ADDENDUM #1

Re: INVITATION FOR BIDS: **16-051-NT Gilead-Bloomfield Renovation**

### Addendum No. 1 Question Responses

# SECTION AT EXERCISE ROOMS

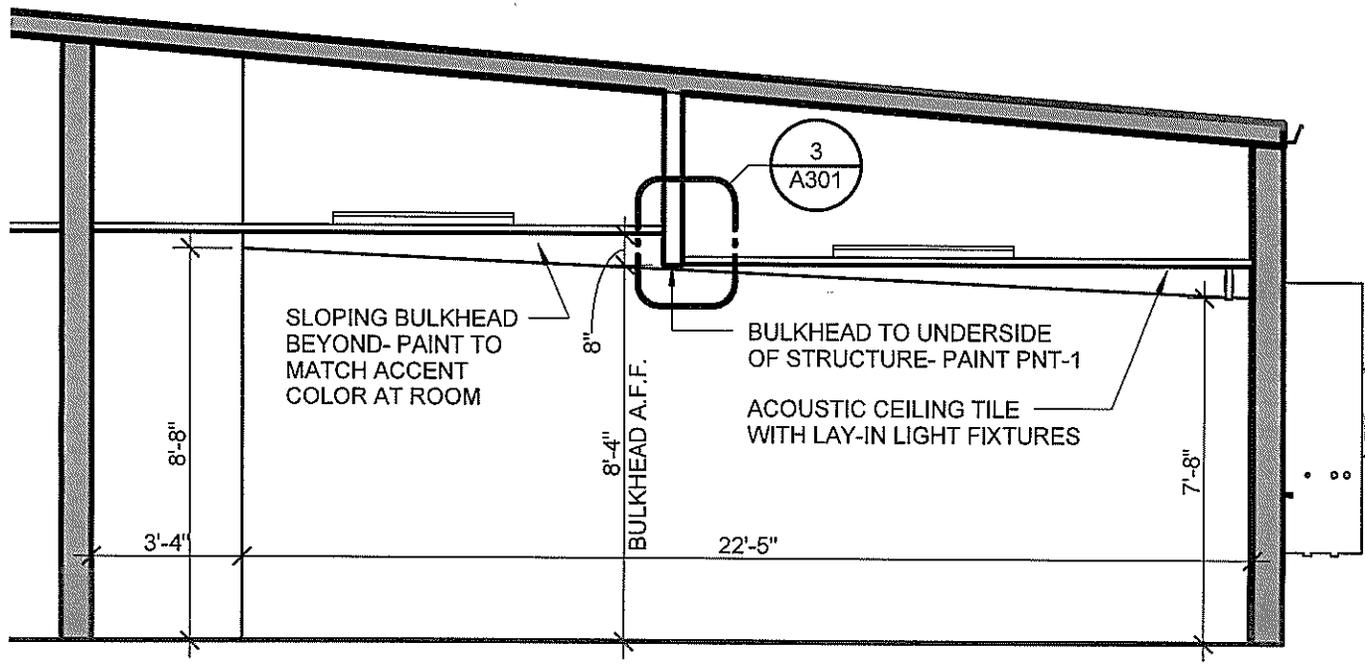
3. Q: The build back plan indicates installing a 10' AFF acoustical ceiling in the Spaces G122 and G123. The existing corridor wall stops at 9'4" AFF. Do you want to lower the ceiling height, or increase the wall height?

A: Lower ceiling heights to 9'-0" and 8'-4" at the exercise rooms as shown in the attached supplemental drawing SD-1 which replaces section 2/A301.

REVISION TO 2/A301
